SECTION 009113  
ADDENDUM NUMBER 3

- 1.1 DATE: December 29, 2021
- 1.2 PROJECT: Orangetown Town Hall Addition and Alterations
- 1.3 Owner: Town of Orangetown
- 1.4 Architect: Lothrop Associates LLP Architects

ELECTRICAL LEVEL 01 PLAN  
(FIRE ALARM)

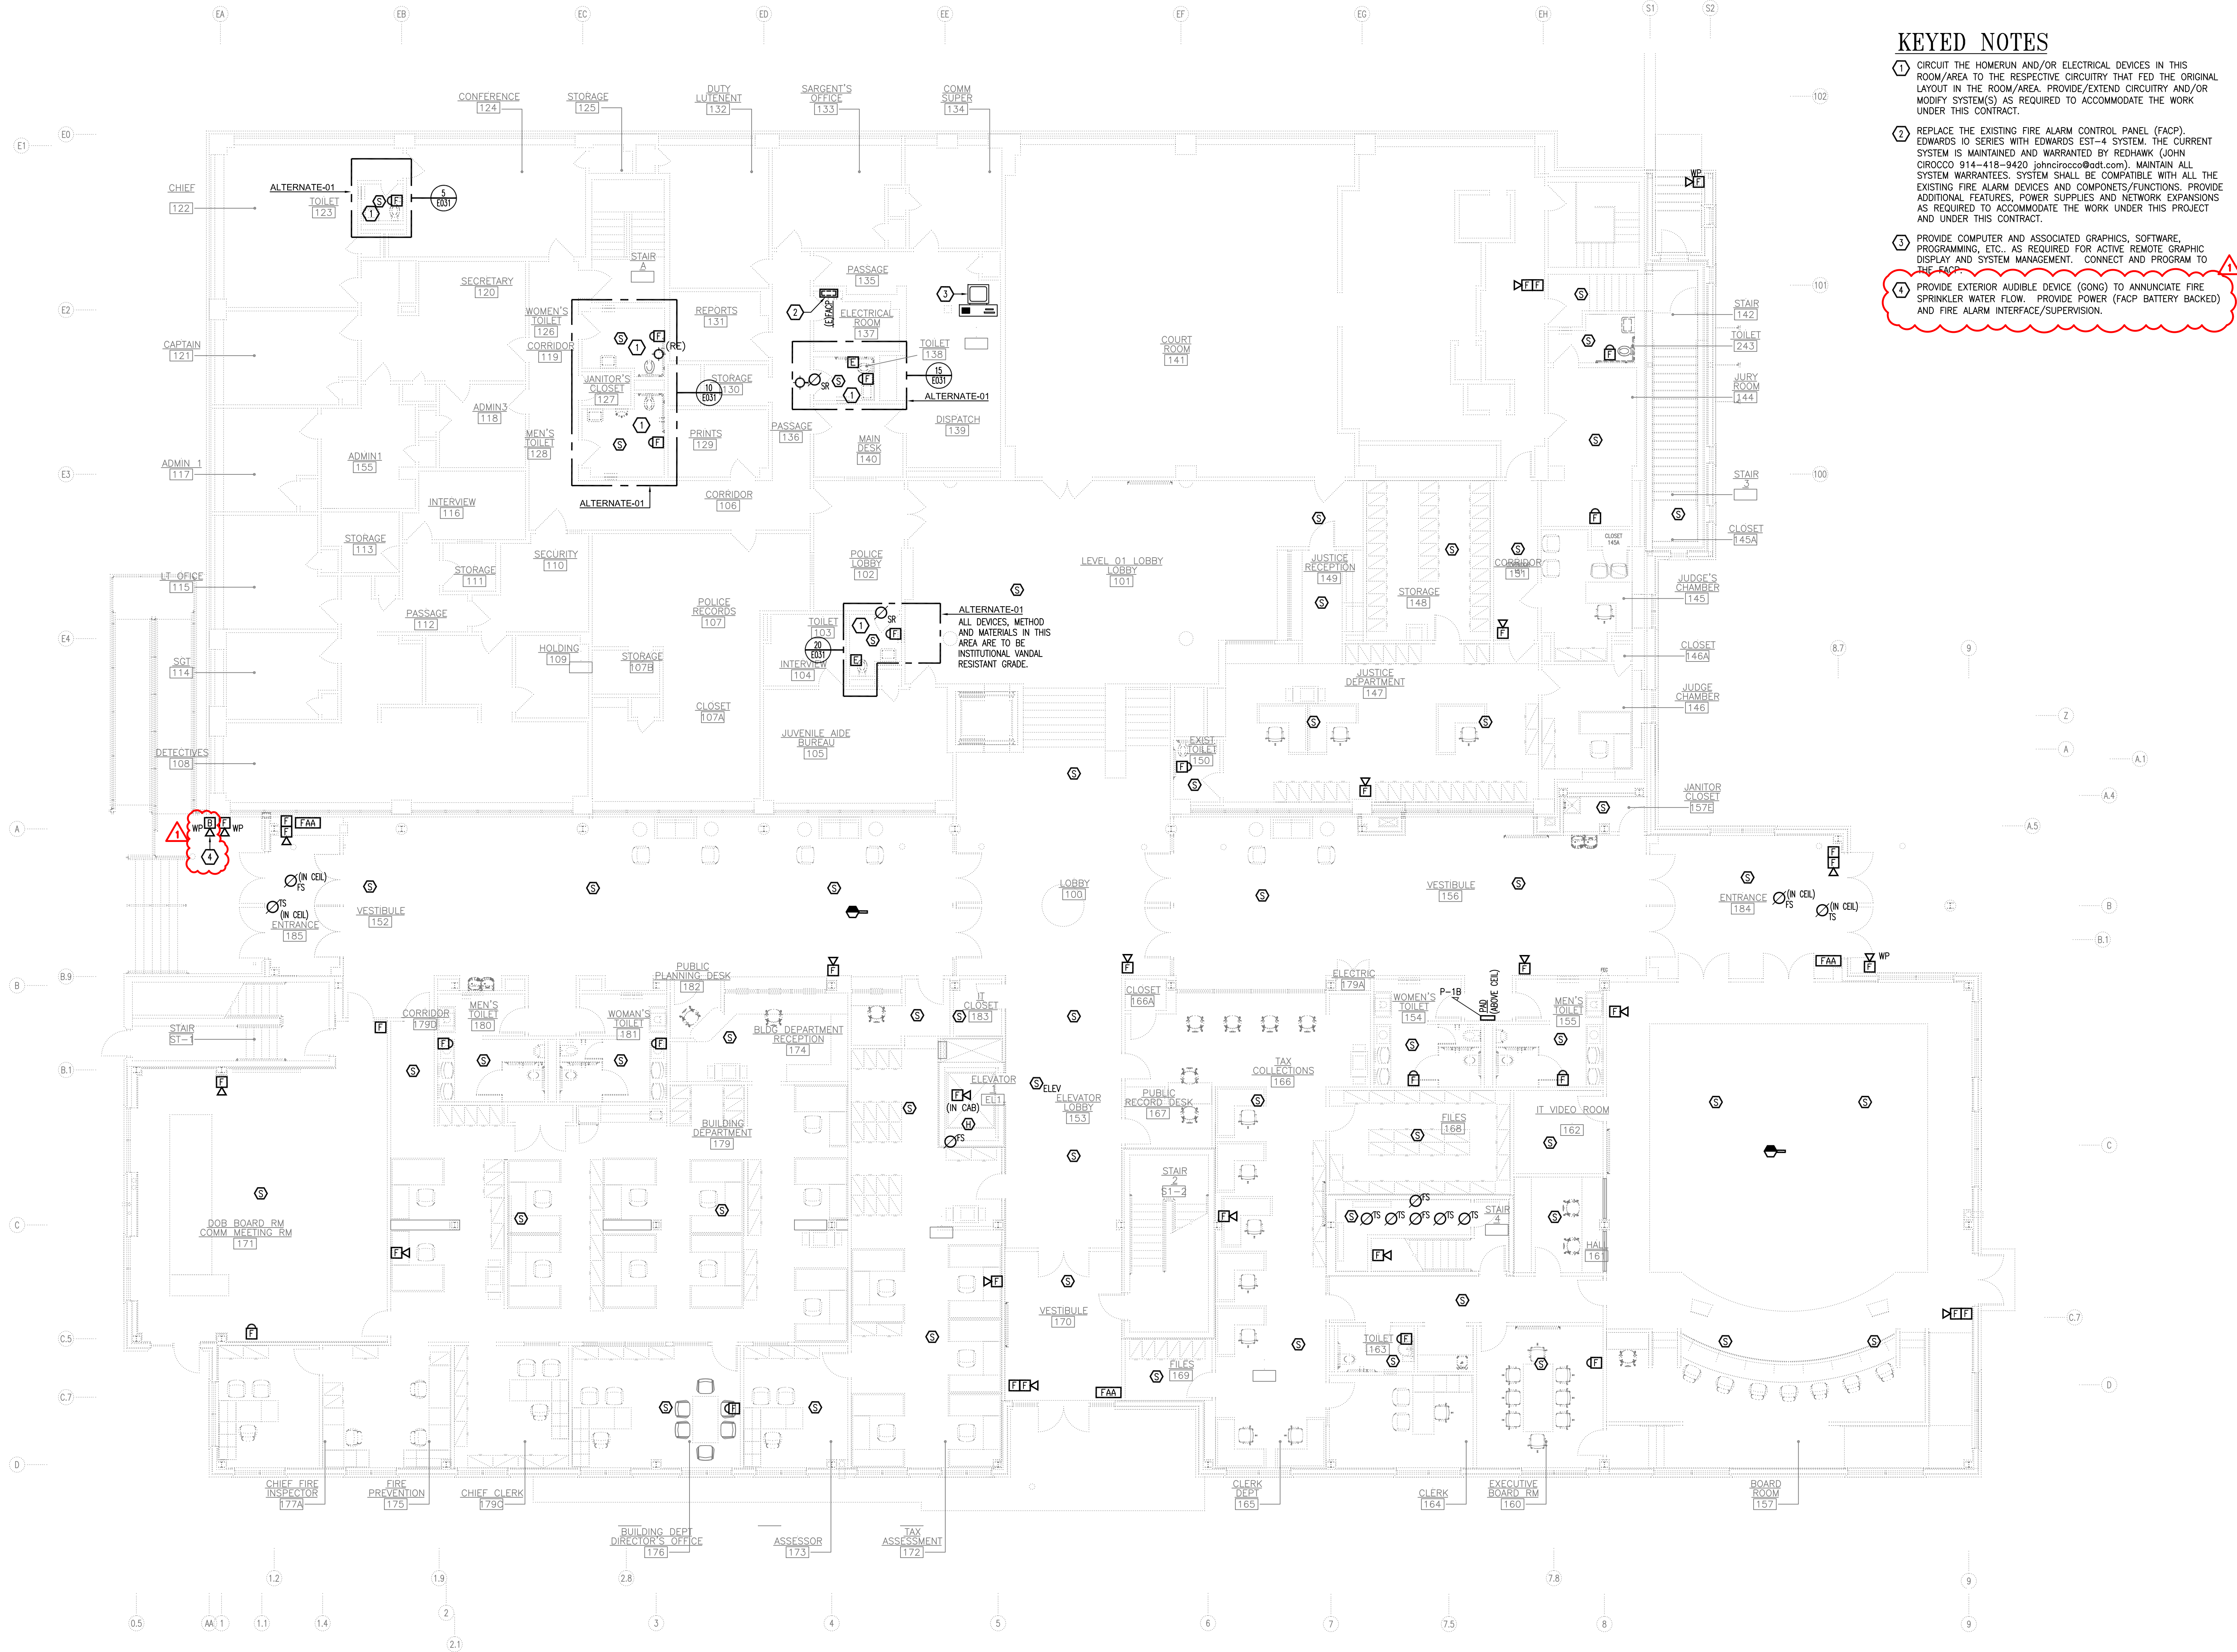
6. Does the building require speakers for fire alarm system? Looks to be horns and horn/strobes by spec. Please clarify. (Architect's RFI #4E.04)
  - a. **The structure is a mixed use occupancy structure, with a primary occupancy of 'B' - Business. All 'A' - Assembly occupancy areas have an occupant load of less than 300, and therefore a voice-capable fire alarm system is not required.**

# ELECTRICAL PART ONE—LINE POWER DIAGRAM, OUTDOOR PLANT FIBER OPTIC DIAGRAM AND KEYED NOTES

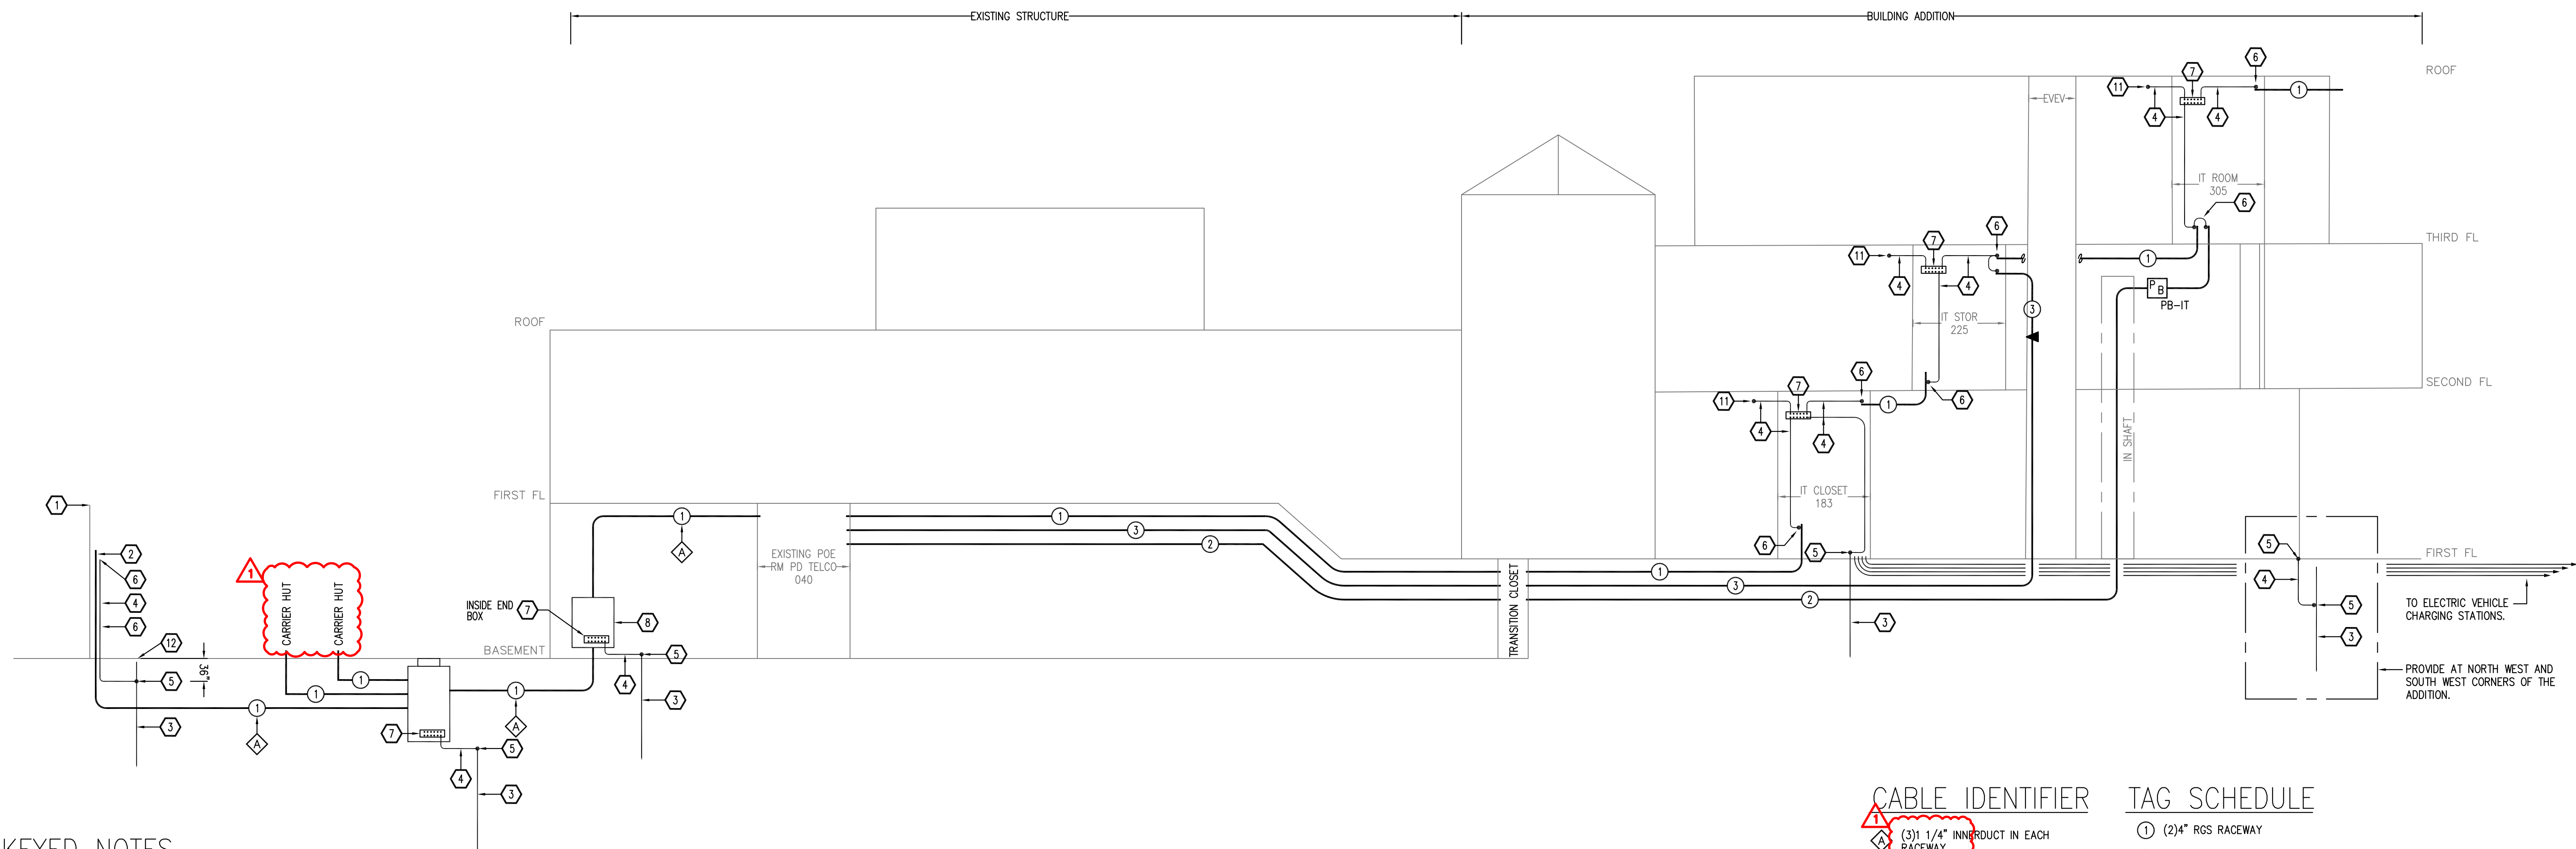
- a. **The work involved requires work by the carriers (utility). These associated costs are to be included in the bid submission.**
20. Drawing E-302 note 3 in circle there is no reference. Also note 31 in octagon. (Architect's RFI #4E.04)

- a. **Change the square with the letter T , dashed line, note 31 and 33 to indicate the existing service transformer and secondary service to remain.**

## 1 IT/COMMUNICATIONS BACKBONE RISER DIAGRAM

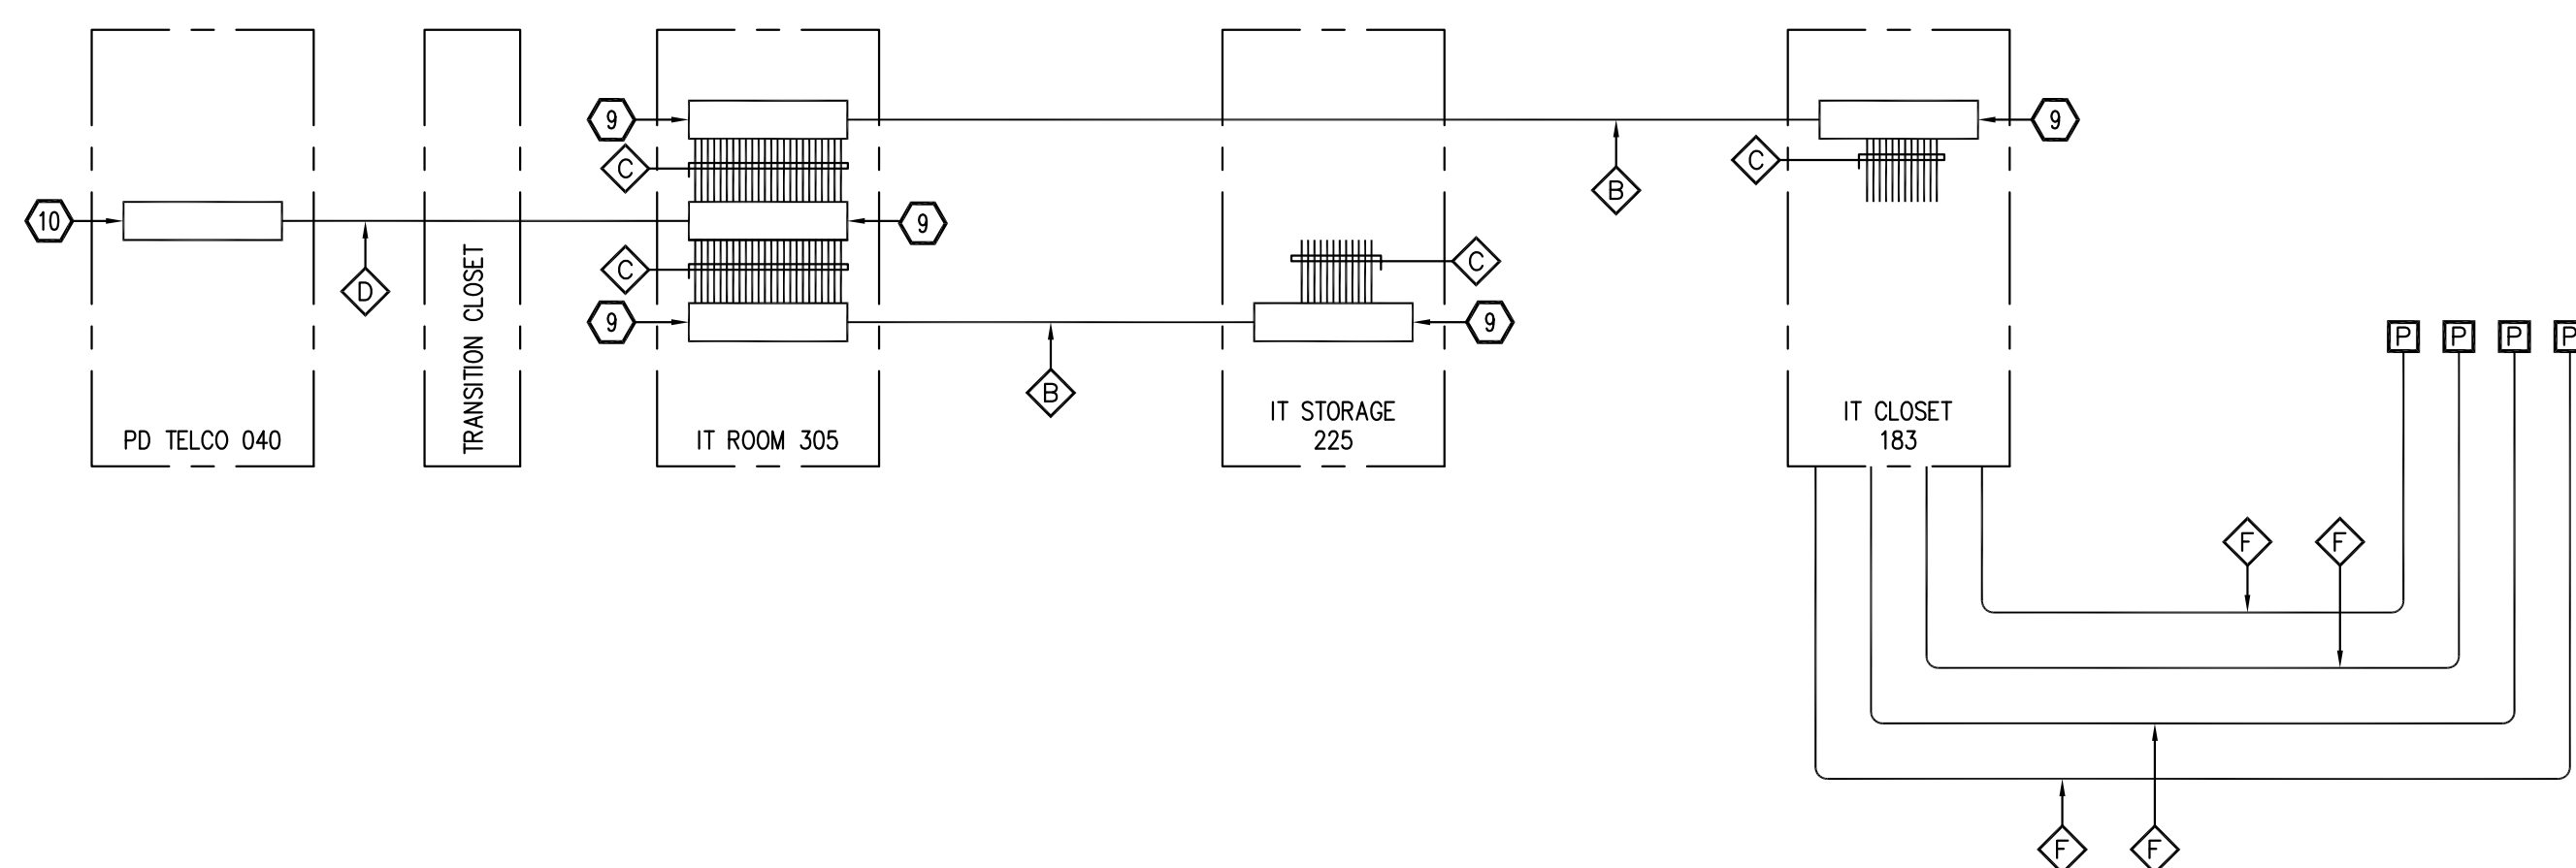
18. Please clarify fiber detail on E-303. Pole to manhole shows Note 1 in circle for (2) 4" pipes and A in diamond says 1 1/4" inner duct. If you use that in conjunction with E-302 keyed Note 18 says pull fiber and Note 3 in circle. What is note 3 and what type of fiber? (Architect's RFI #4E.04)

- a. **Refer to revised drawings E-303 and E-307, attached to this Addendum.**
19. For the site drawings and service provider usually the terminations and wire for service provider to demark is done by service provider. We normally provide conduits only. Are we sure the site is correct? Also how many providers are there? We want to clarify we are doing work for the carrier overhead and terms on their equipment poles, per drawing E-302, notes 1 and 2. (Architect's RFI #4E.04)
